100 Marsac Avenue – Remand of Appeal of Staff’s PL-09-00709

Historic Preservation Board Staff Report

Subject: Appeal of Historic District Design Review for 100 Marsac Avenue
Author: Katie Cattan, AICP
Date: February 6, 2013 (Continued from January 16, 2013)
Type of Item: Quasi-Judicial

Front Facade of Homes 1-6 Located on Downhill Lots.

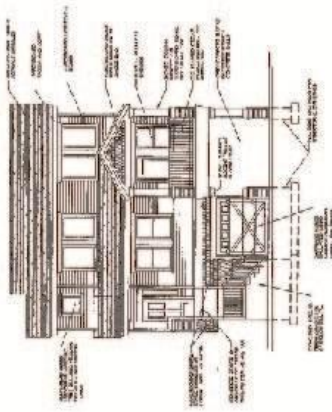
1) House designs are not sufficiently different as required by the conditions of the MPD
--

The applications for the Historic District Design Review (HDDR) include 10 single family homes. There are 2 different floor plans included for the submittal. One floor plan for new homes on the downhill lots (homes 1 – 6) and one floor plan for the uphill lots (homes 7 – 10). Within the floor plans there is some variation of garage and entryway locations. The Architect created further variation on the exterior of the homes through changes in location and design of windows, doors, porches, and dormers. The exterior siding of the homes includes the use of board and batten, horizontal lap siding, and vertical siding. Staff found that the design complies with condition of approval #2 of the MPD. This condition of approval was reviewed within the HDDR application, therefore this point is included within the appeal. Staff has compiled the approved exterior front facades for the HPB to review for compliance with Condition of Approval #2 of the Master Planned Development. Exhibit O has been included with the HPB packet as a 11” x 17” printout for the HPB’s review.

Condition of Approval #2 of the Master Planned Development approval states “All buildings will be required to be reviewed under the Historic District Design Guidelines. The specific house designs shall be sufficiently different to provide variety and interest.”

Front Facade of Homes 7-10 Located on Uphill Lots.

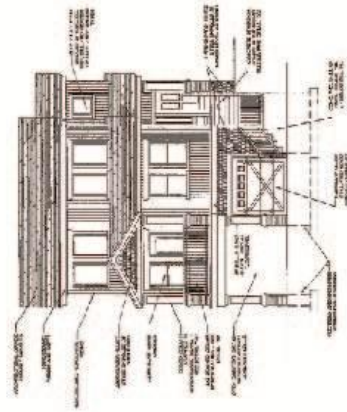
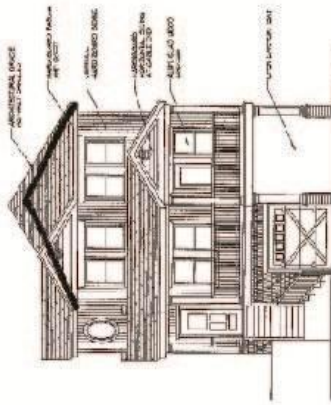
Unit 8, revised elevations indicate a prominent elliptical window on the front façade. This is inconsistent with park City' historic architecture and prior actions of the HPB.

Staff Analysis: **Complies.** The majority of the windows within all home designs are double hung. Homes 8 and 10 introduced one elliptical window to provide variation in design. Elliptical windows are not prohibited.

5 BOULDER RET. DETAIL nts

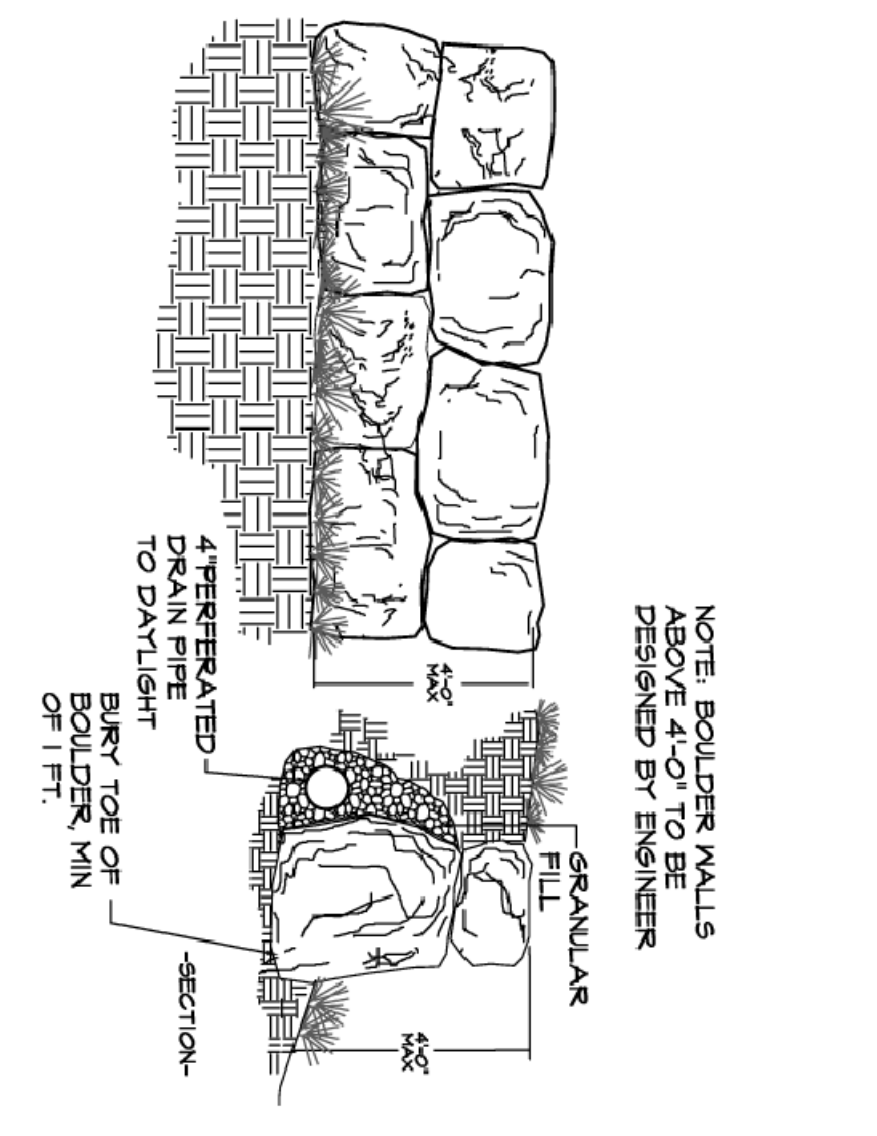
The Architectural site plan of August 29 2008 indicates concrete (assumed) retaining walls between the downhill units in order to accommodate side yard parking areas. Boulder retaining walls are shown behind the uphill units running the length of the developed lots. These boulder walls are shown to be approx four feet high on the building elevation drawings in the application. This entire plan was revised prior to the approval of the subdivision as (amongst other issues) it was demonstrated that the proposed layout failed to meet setback criteria.

The only drawings added to the Historic District Design Review file, dated January 2009, show the rear of the uphill units with boulder retaining walls in excess of ten feet.

This is discouraged by the Historic District Design Guidelines (current and pending) and is in conflict with the LMC requirements for retaining walls to be less than six feet high in the rear (or side yards).

Staff Analysis: **Discussion Requested.** Changes to the retaining walls occurred between the October 22, 2008 Steep Slope CUP approval and the site plan dated January 20, 2009 within the Historic District Design Review application.

The January 9, 2013 HDDR site plan locates one “exposed bedrock or soil nail wall” 20 foot high retaining wall at the turn-round. No illustrations of the proposed soil nail wall were submitted. The January 9, 2013 HDDR site plan includes two to three 6 feet tall boulder retaining walls along the rear yard of the uphill properties. Two six foot high boulder walls are proposed above the 20 foot high exposed bedrock/soil nailed 20 foot wall. Retaining in this area will exceed 30 feet within an expanse of thirty feet. No illustrations of the proposed walls were submitted. Boulder size, rock type, and method of construction are unknown. Staff requested an updated streetscape including the retaining walls. A new streetscape was not provided by the applicant.

During the original review of the HDDR, staff found that the proposed boulder retaining walls along the rear and side yards of the properties and the exposed bedrock or soil nailed wall at the turn-around as shown in the January 20, 2009 site plan complied with Guideline #70. The changes between the SS CUP application and the HDDR were not determined to be substantial by staff. Therefore staff approved the changes in the retaining walls within the HDDR application.
